# **Site Accessibility Evaluation**

**Cabrillo Pavilion**  
**1118 E Cabrillo Blvd**  
**Santa Barbara, CA 93103**  
**Accessibility Evaluation**  
**Inspection Date: 08/24/2023**  
**Inspectors: Scott Saddlemire**

**Report Date: 11/03/2023**

### Finding: 1

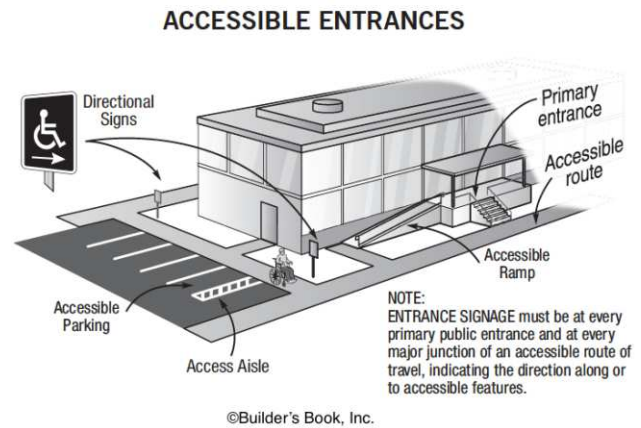
The accessible parking is not located on the shortest accessible route to the building entrances.

Where parking serves more than one accessible entrance, accessible parking spaces shall be dispersed and located on the shortest accessible route to the accessible entrances.

### Finding: 2

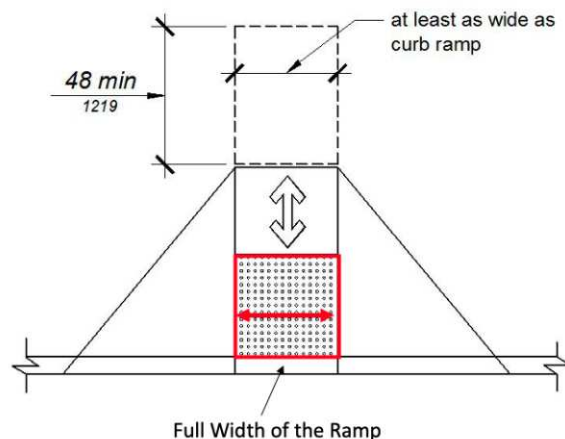
The detectable warnings are not the full width of the curb ramp.

Detectable warnings at curb ramps shall extend the full width of the ramp run less 2 inches maximum on each side, excluding any flared sides and 36 inches in the direction of travel.

### Finding: 3

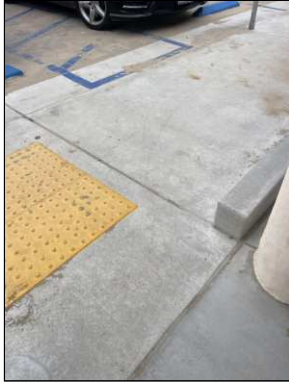
The detectable warning on the turning space is not the minimum required width.

Wrong location of the detectable  
warnings

these detectable warnigns are not installed full width and are not in the correct location

### Finding: 4

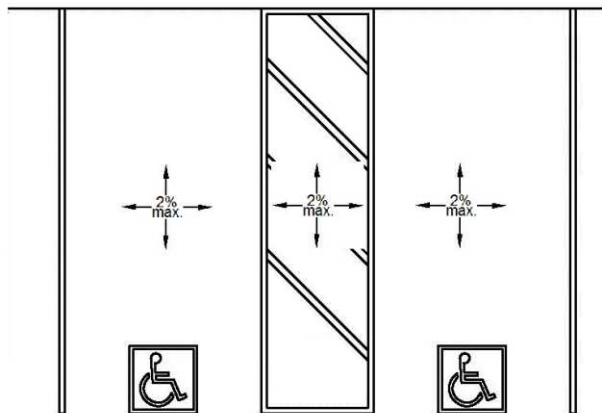
The running slope (long dimension) of the accessible parking stall exceeds 2%.

The running slope in an accessible parking stall and the access aisle must not exceed 2%.

### Finding: 5

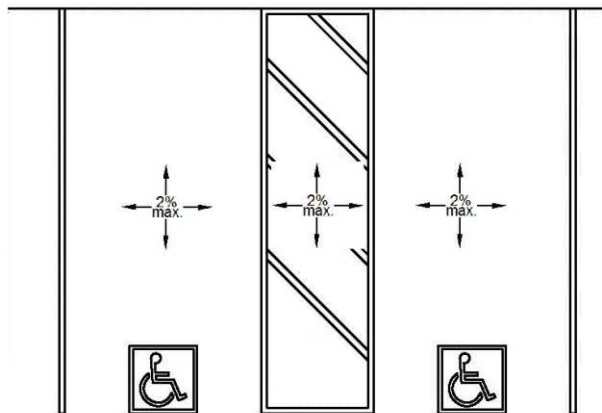
The running slope of the access aisle (long dimension) exceeds 2%.

The running slope in an accessible parking stall and the access aisle must not exceed 2%.

### Finding: 6

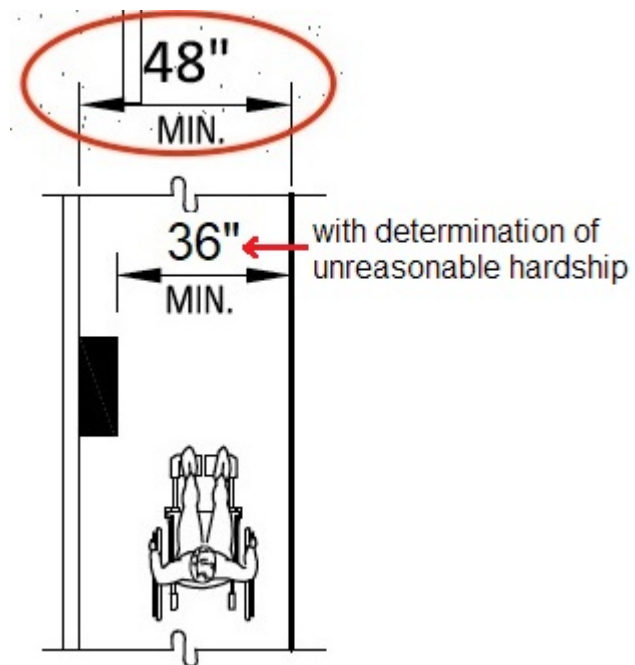
The route of travel does not provide the required minimum width.

The minimum clear width for sidewalks and walks is 48 inches.

obstructed

maintenance required

### Finding: 8

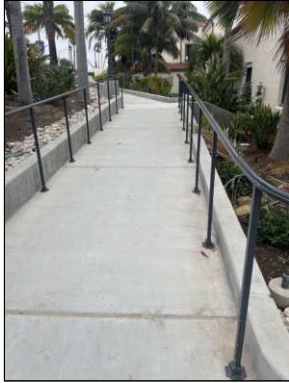
The ramp run and landing do not have compliant/required edge protection.

A curb, or barrier shall be provided that prevents the passage of a 4 inch diameter sphere, where any portion of the sphere is within 4 inches of the finish floor or ground surface. To prevent wheel entrapment, the curb or barrier shall provide a continuous and uninterrupted barrier along the length of the ramp.

rail guide

### Finding: 9

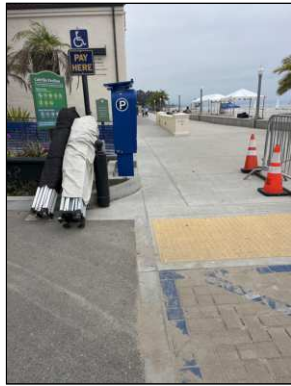
The detectable warning on the turning space is not the minimum required width.

Where the turning space has one entrance/exit point other than the sloped ramp segments, detectable warnings shall be 36 inches deep, as measured perpendicular to the curb, and the turning space shall provide minimum 36 inches wide portion without detectable warnings to allow pedestrian travel in the direction of the sidewalk without travelling over the detectable warnings.

### Finding: 12

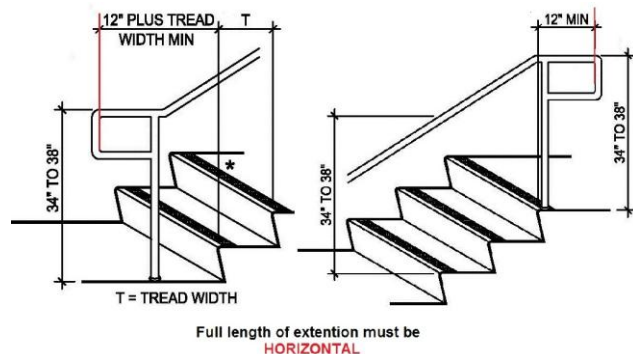
The stairway does not have handrails.

Stairways must have handrails on both sides.

This stair appears to have been part of the recent alteration and should have been updated

### Finding: 15

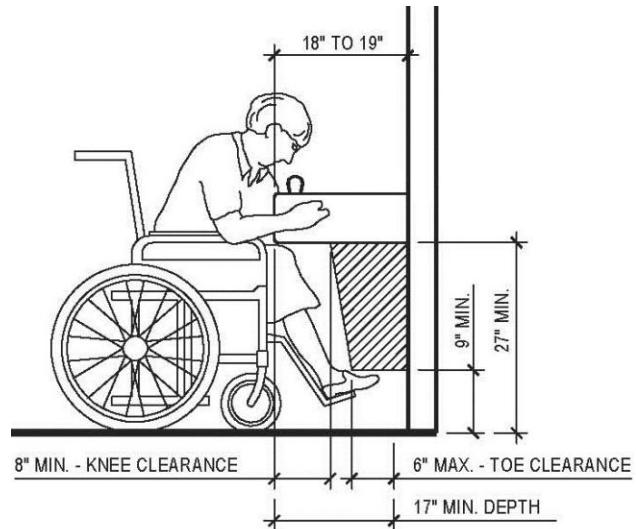
There is not enough knee clearance under the drinking fountain.

The drinking fountain must have a clear knee space between the bottom of the drinking fountain and the floor not less than 27 inches in height, 30 inches in width, and 8 inches in depth.

### Finding: 16

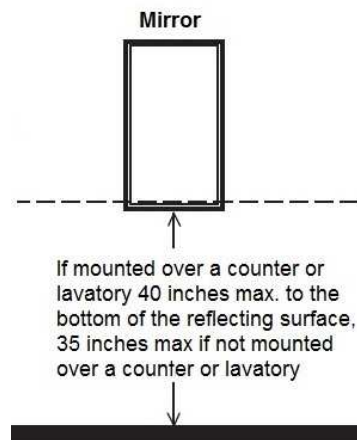
The mirror is mounted above 35 inches above the finished floor or ground surface.

Mirrors not located above lavatories or countertops shall be installed with the bottom edge of the reflecting surface 35 inches maximum above the finish floor or ground.

not 35" to reflective surface

### Finding: 17

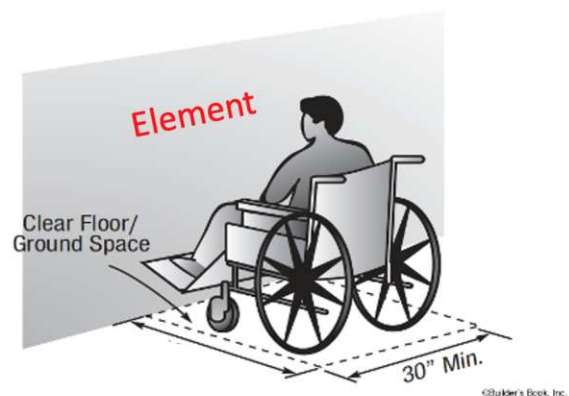
The baby changing table is not provided with a forward approach.

Baby changing tables must be provided with a forward approach. Knee and toe clearance shall be provided.

Too Low

#### Recommendation: repair

**Exterior Accessible Routes: Men's Restroom South Side****Finding: 18**

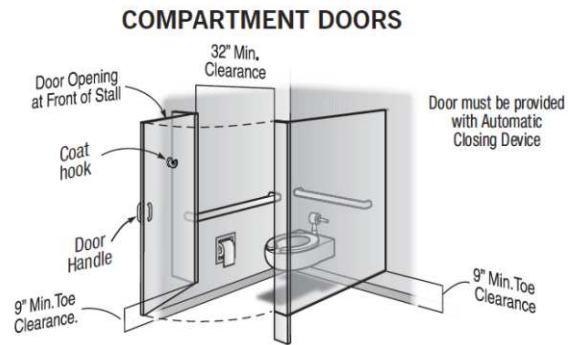
**The compartment door is not self closing.**

**The water closet compartment shall be equipped with a door that has an automatic-closing device.**

**Citation:****As Built:****2010 ADAS Section: 604.8.1.2****N/A****2022 CBC 11B Section:  
11B-604.8.1.2****Recommendation:  
maintenance is required**

### Finding: 19

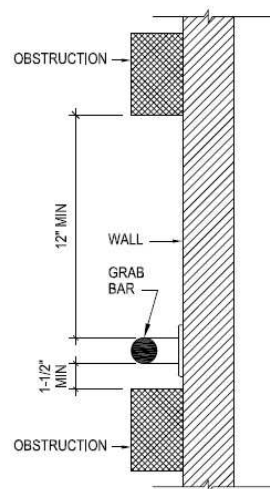
The toilet flushometer valve is mounted too close to the bottom of the grab bar, minimizing the gripping surface.

Adjacent elements shall be positioned to provide unobstructed use of grab bars. The space between the grab bar and projecting objects below and at the ends shall be 1-1/2 inches minimum. The space between the grab bar and projecting objects above shall be 12 inches minimum.

### Finding: 20

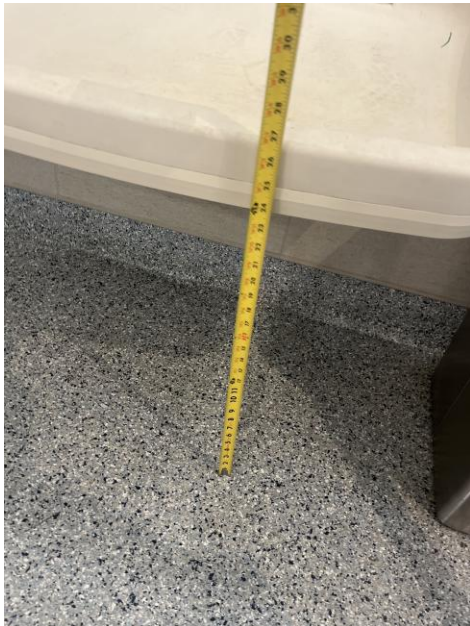
The baby changing table is not provided with a forward approach.

Baby changing tables must be provided with a forward approach. Knee and toe clearance shall be provided.

too low

### Finding: 21

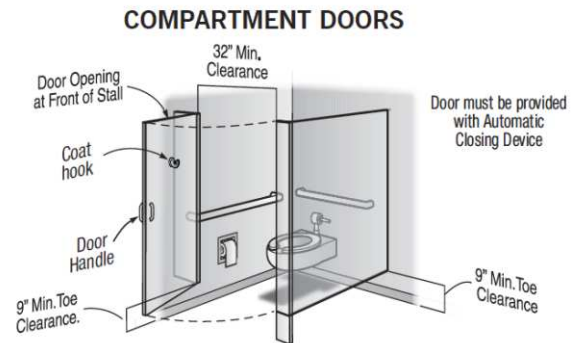
The compartment door is not self closing.

The water closet compartment shall be equipped with a door that has an automatic-closing device.

**Recommendation:**  
maintenance is required

### Finding: 22

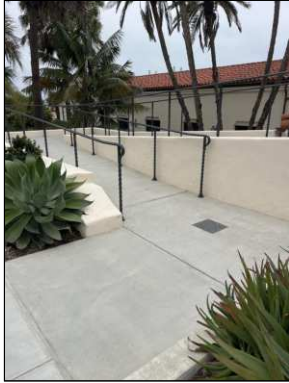
The walk is missing directional signage that identifies the location/direction of the accessible route of travel to the accessible building entrance.

There are a couple of these entrances off the main street with no signage stating where they lead to and if it's an accessible route. Recommend adding signage

### Finding: 23

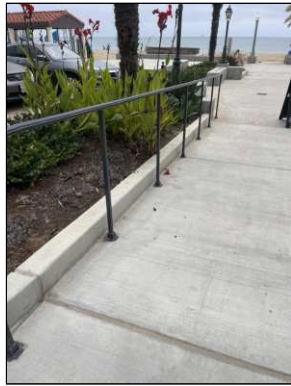
The ramp run and landing do not have compliant/required edge protection.

A curb, or barrier shall be provided that prevents the passage of a 4 inch diameter sphere, where any portion of the sphere is within 4 inches of the finish floor or ground surface. To prevent wheel entrapment, the curb or barrier shall provide a continuous and uninterrupted barrier along the length of the ramp.

chair guide

wheel guide is missing

### Finding: 24

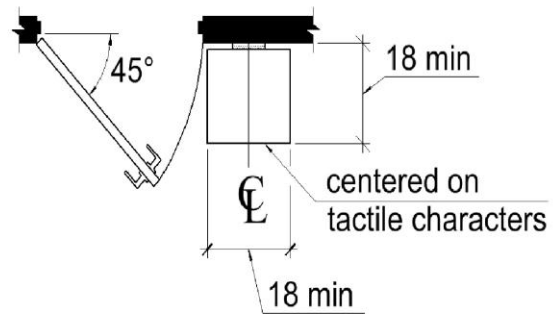
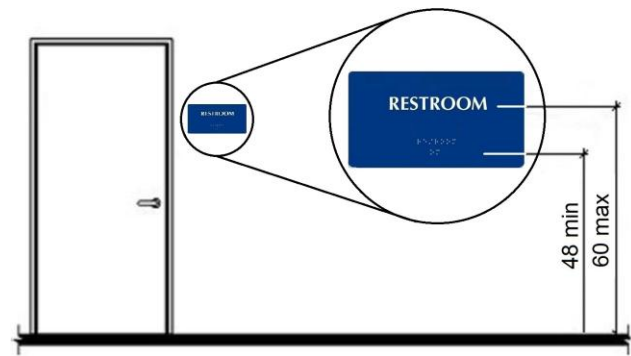
The wall sign is incorrectly located.

Where permanent identification signs are provided for rooms and spaces, signs shall be installed on the wall adjacent to the latch side of the door. Where there is no wall space on the latch side, including at double leaf doors, signs shall be placed on the nearest adjacent wall, preferably on the right.

not on strike side of door

install on strike side of door

### Finding: 25

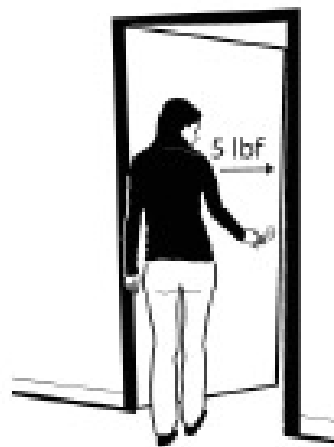
The door exceeds the maximum allowable opening force.

Doors shall have a maximum opening force of 5 pounds.

### Finding: 27

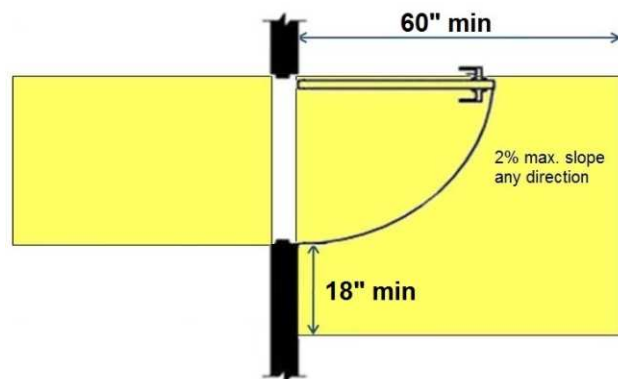
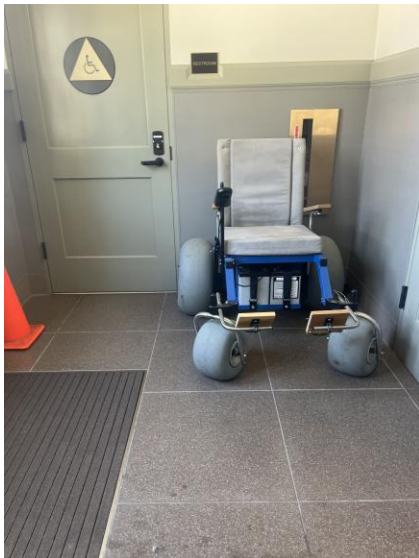
The maneuvering clearance on the pull side of the door extends less than 18 inches beyond the latch side of the door.

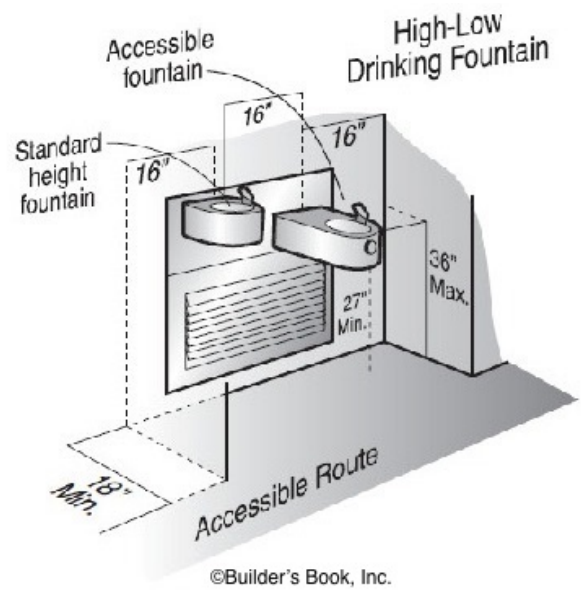
The spout shall provide a flow of water at least 4 inches high minimum and shall be located 5 inches maximum from the front of the unit. The angle of the water stream shall be measured horizontally relative to the front face of the unit.

not 16" to side wall

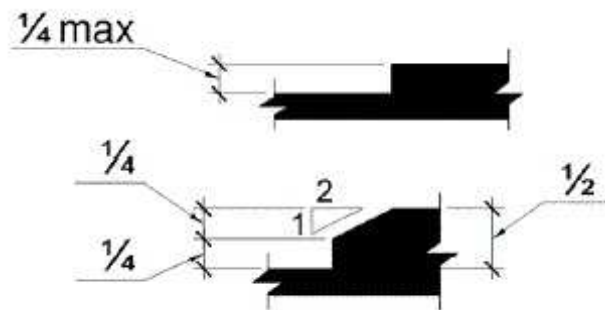
There is a change in level that exceeds the allowable range.

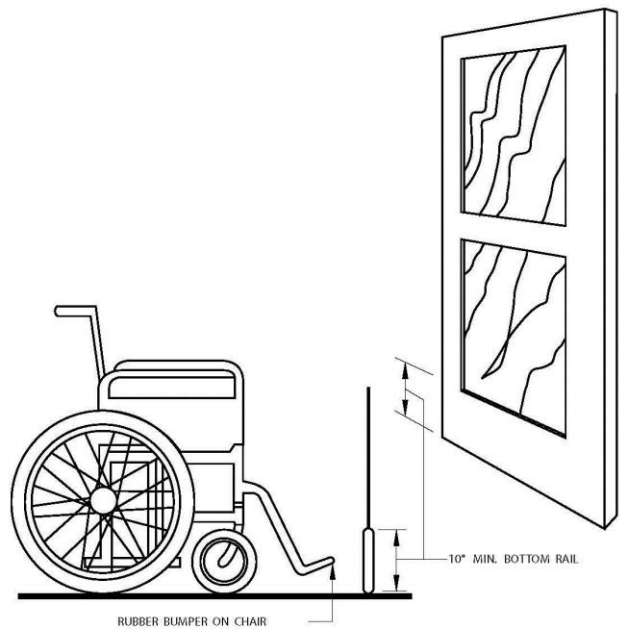
Swinging door surfaces within 10 inches of the finish floor or ground measured vertically must have a smooth surface on the push side extending the full width of the door. Parts creating horizontal or vertical joints in these surfaces shall be within 1/16 inch of the same plane as the other. All gates, including ticket gates, shall meet all applicable specifications for doors.

typical for both exit doors to the  
patios
